- d. 988 Howard Avenue, zoned MMU - Environmental scoping and Design Review for an application for Environmental Review, Commercial Design Review, Conditional Use Permit for building height, and Setback Variance and Parking Variance for a new 3-story commercial building (Dimitrios Sogas, applicant; Robert Lugliani, property owner; Toby Levy Design Partners, architect) (42 noticed) Staff Contact: Catherine Barber

988 HOWARD AVENUE
APN: 028 214 220
BURLINGAME, CA
PROJECT NO. 2014-21

DATE: 02-27-2015
SET ISSUE: PLANNING COMMISSION

**PRE-DEVELOPMENT
HYDROLOGY MAP**

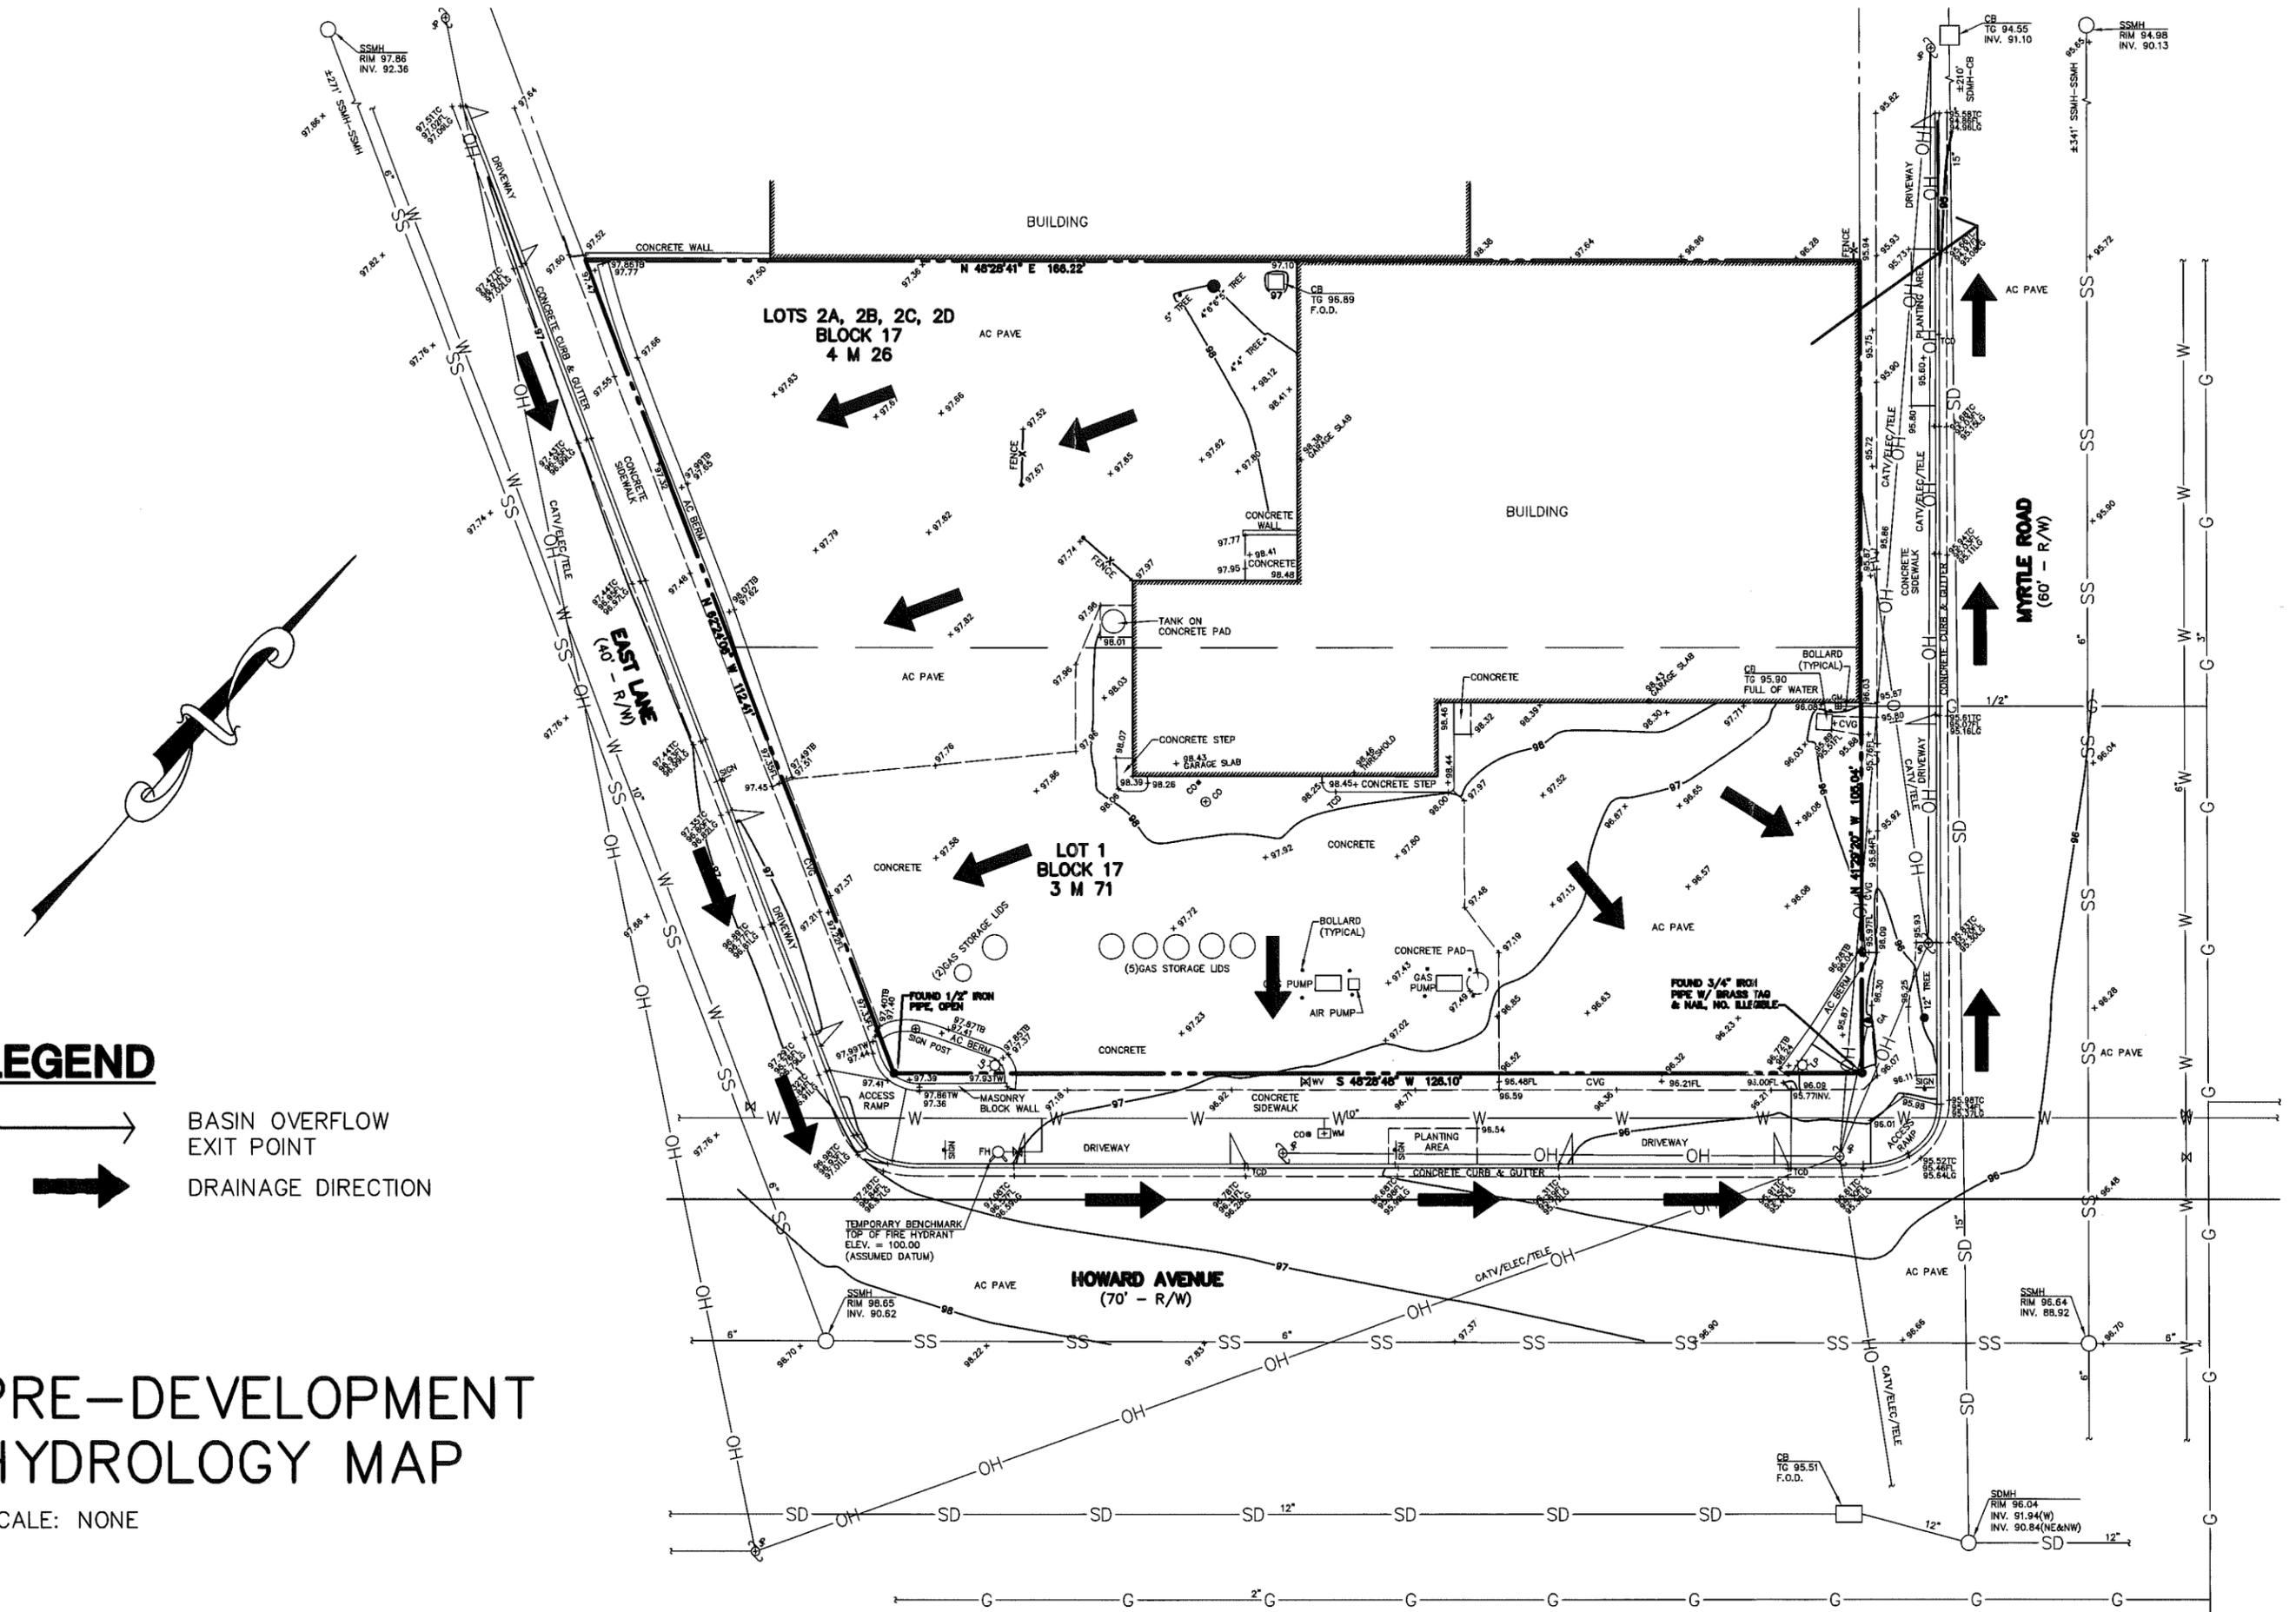
1. On the survey or site plan, please show where the stormwater runoff is currently being directed to. There is a CB on the survey and site plan but it does not show where it directs the runoff.

1. See enclosed Pre-Development Hydrology Map. It shows where the stormwater runoff is currently directed. It is all sheet flow from the site and ultimately collected at the northerly corner of the property on Myrtle. The connection of the existing catch basin is unknown.

1 PLAN: ROOF PLAN
1/8"=1'-0"

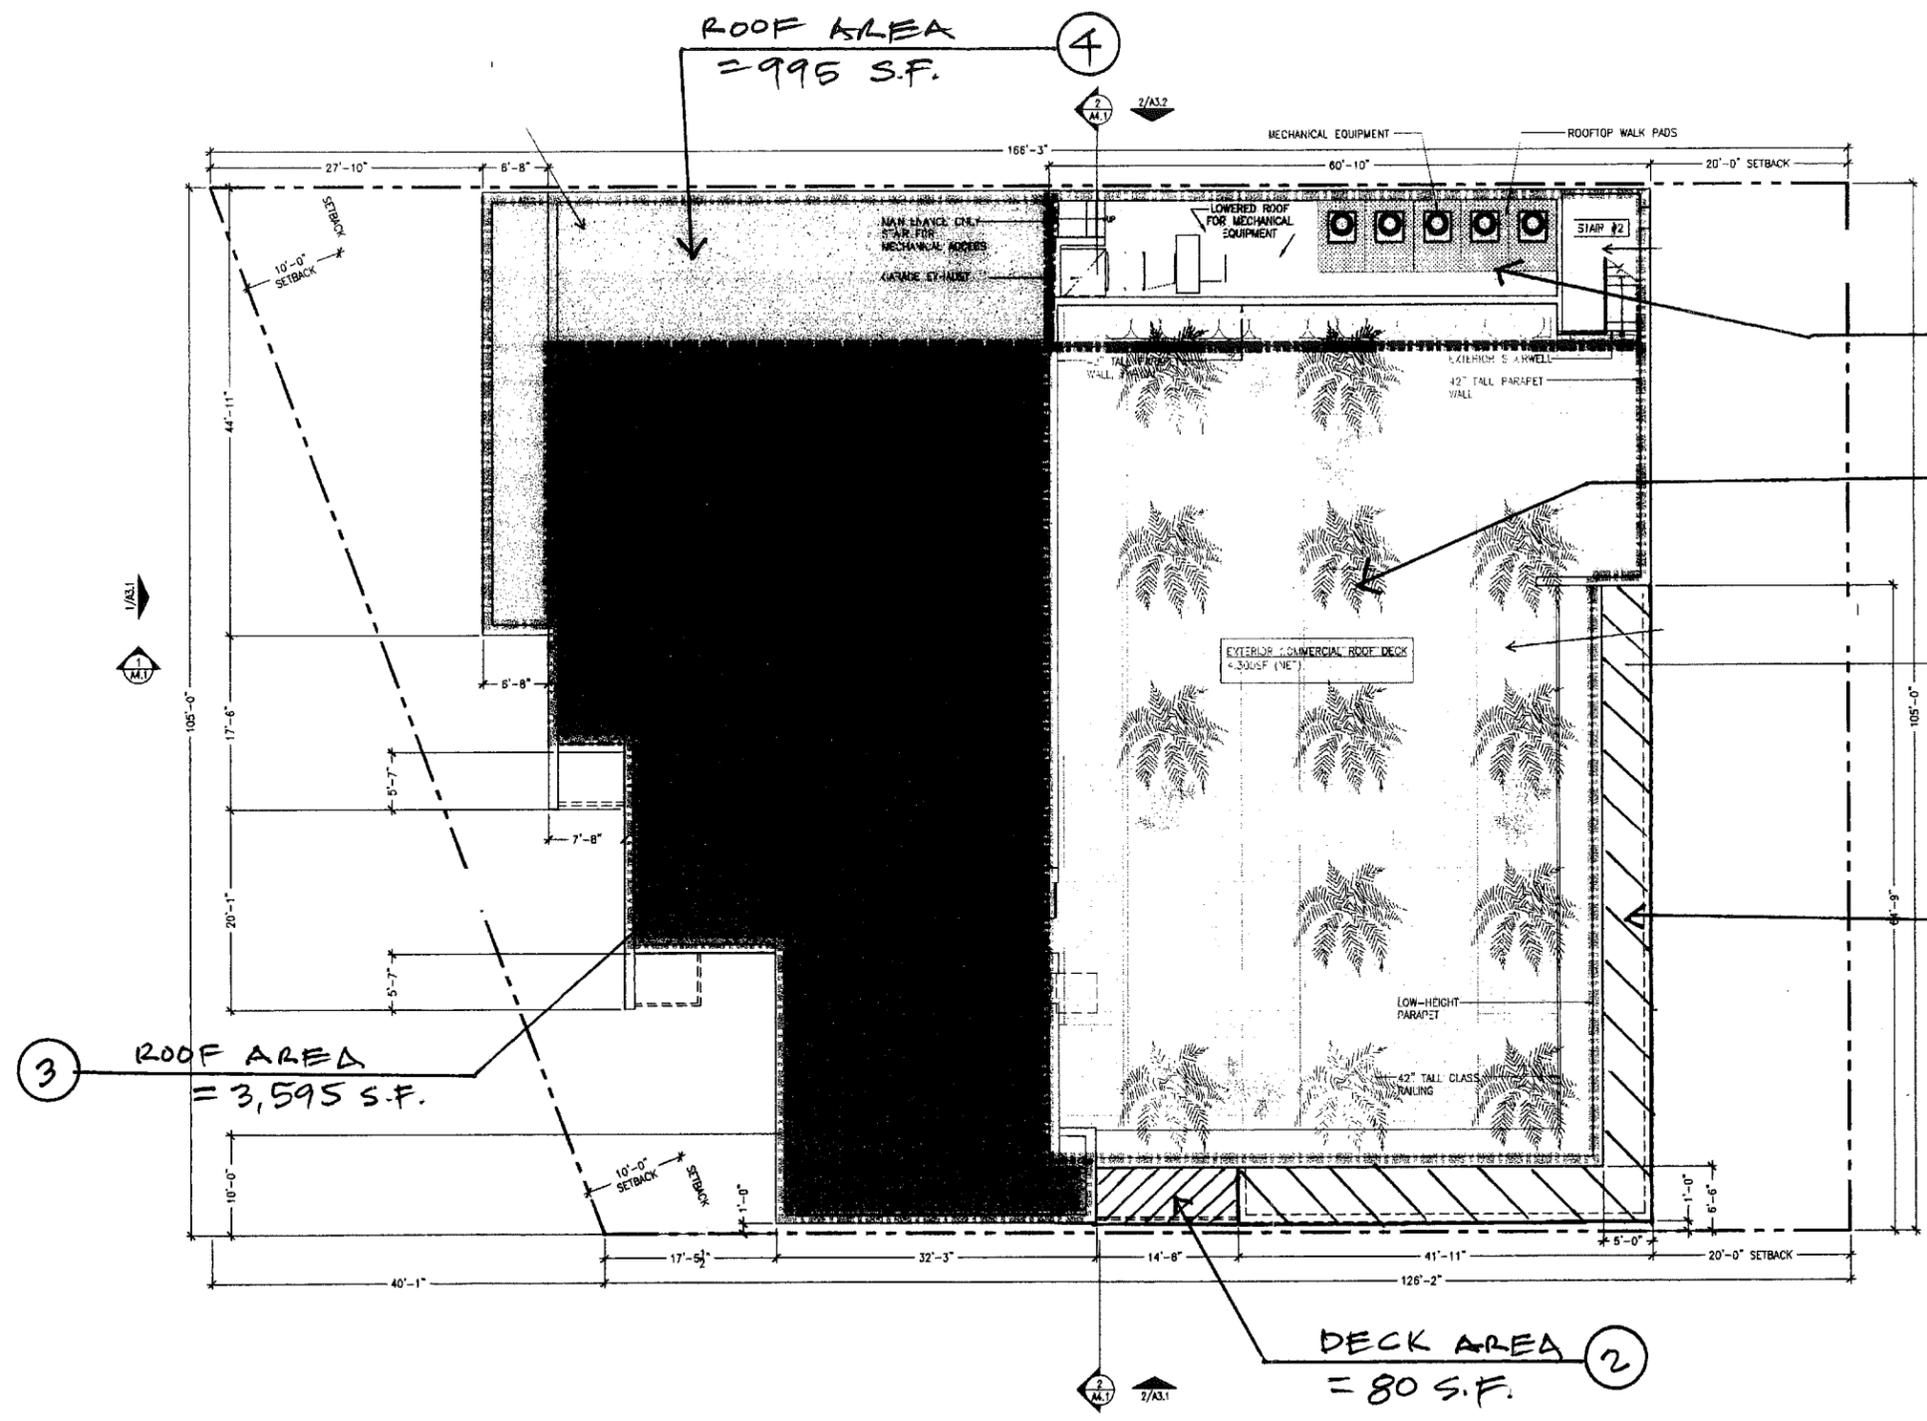
The two upper stories appear to me to be very "clunky" and top-heavy, though that surely was not the intent. This is most evident on Pg. A3.3 of the renderings #2 and #3, that show the very large cube-like structure with heavy dark colored protrusion (accommodating two deep and wide decks) that further makes the entrance below it look somewhat lost, perhaps recessed into shadow at certain times. Note that rendering #1 only poorly indicates what #2 and #3 show. See pages A 2.3 and A 2.2 (Decks 3 and 4) to see what is actually

1 PLAN: GROUND FLOOR
1/8"=1'-0"

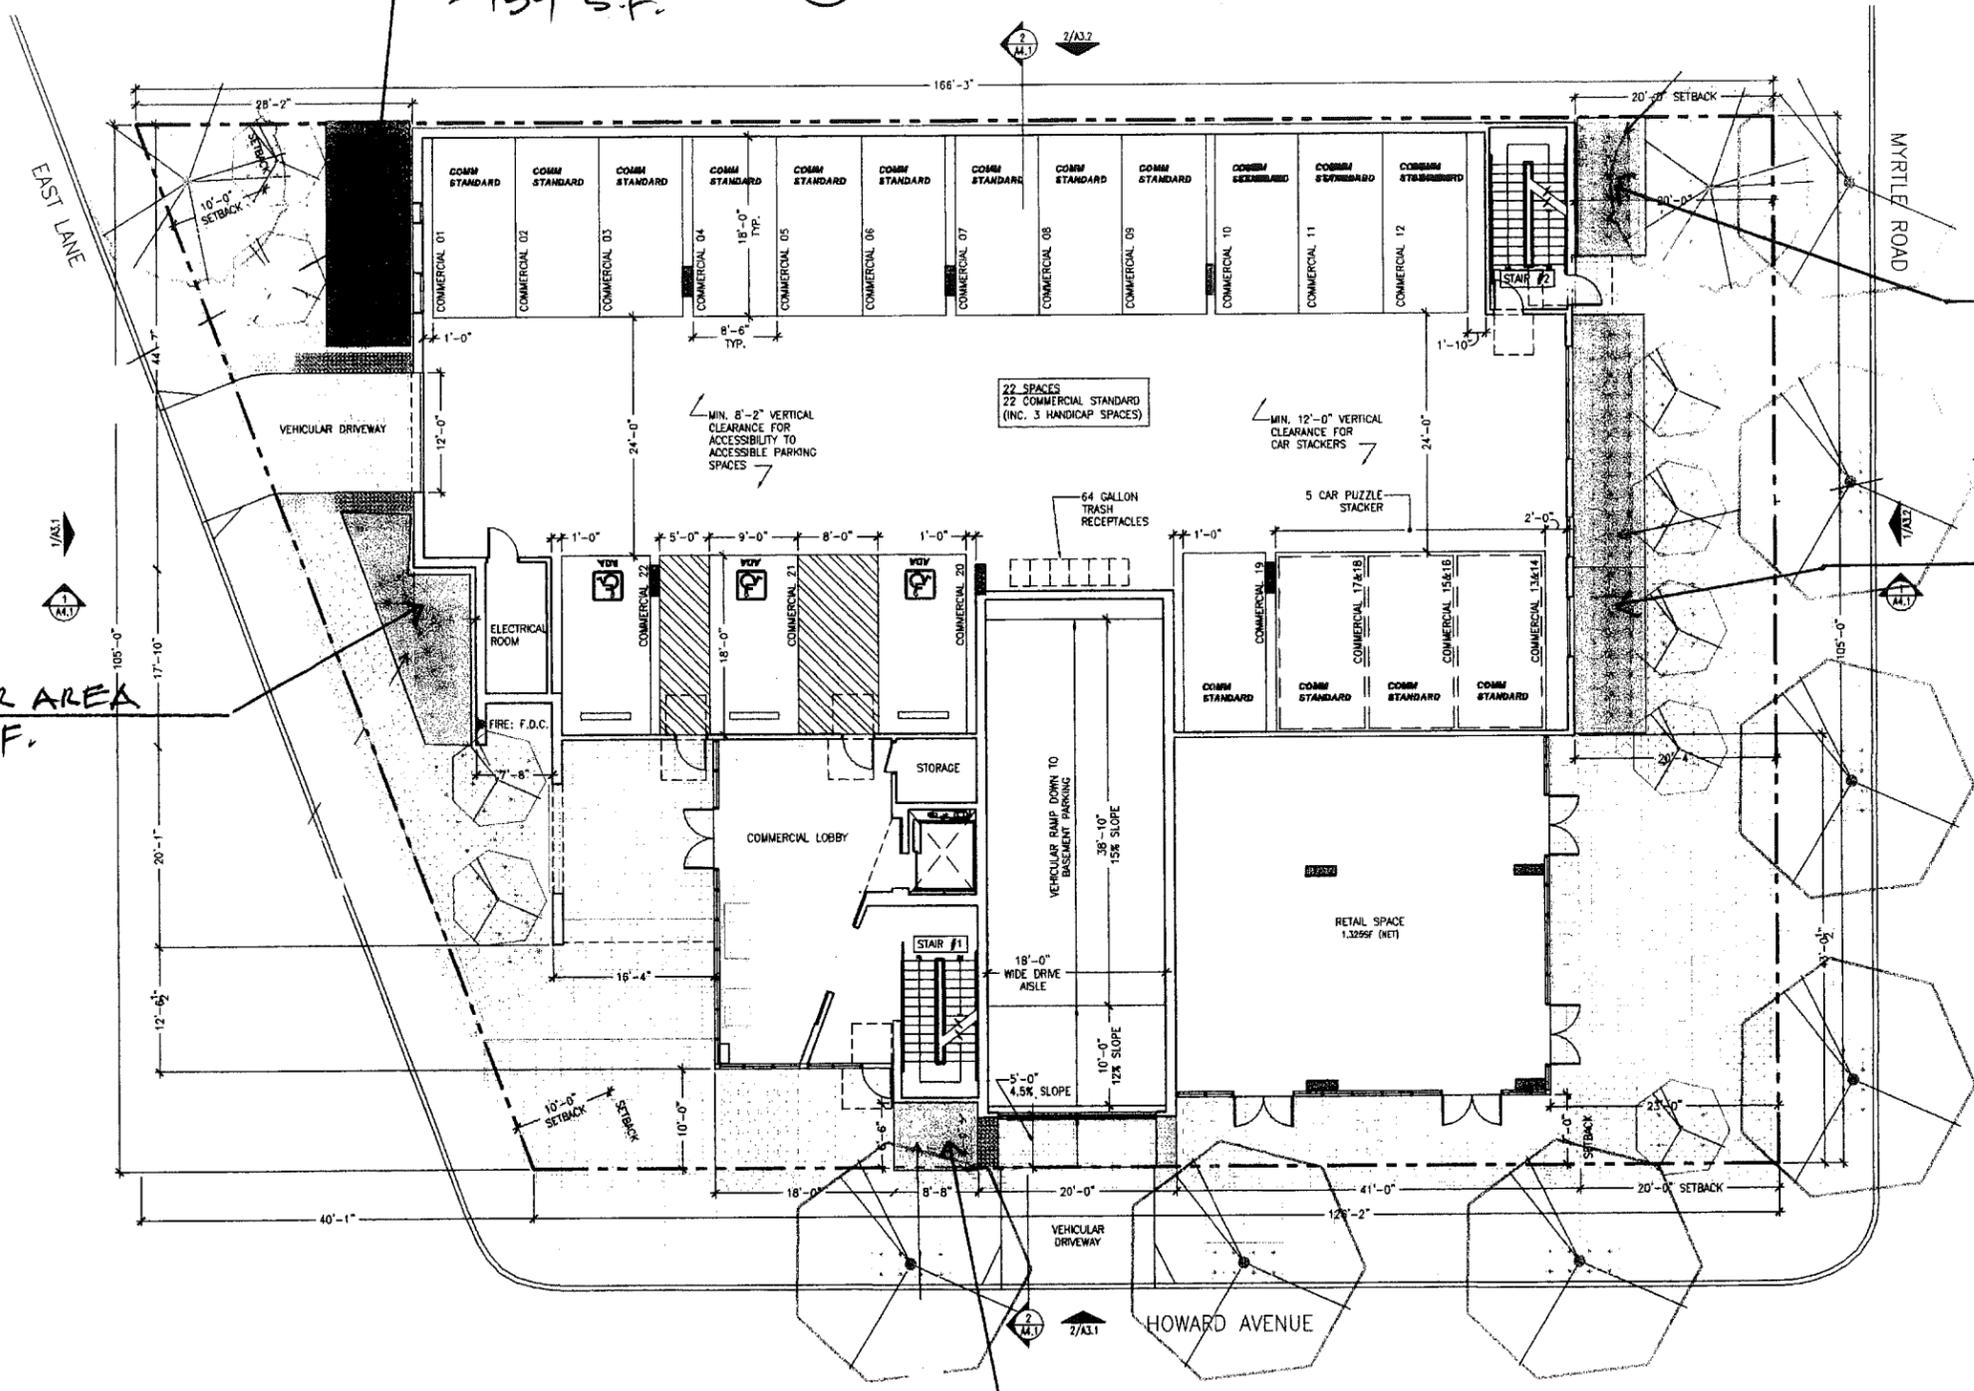
- 31) In the commercial space shown on sheet A2.1 provide details that show a minimum of one accessible Uni-sex restroom in the tenant space.
- 32) Provide details on the plans which show that the entire site complies with all accessibility standards. NOTE: If full accessible compliance cannot be achieved complete the attached *Request for Unreasonable Hardship*.

- 44) Remove all references to the ADA (see the accessible parking on sheet A2.1) as this project must comply with the 2015 CBC, Chapter 11B not the ADA.
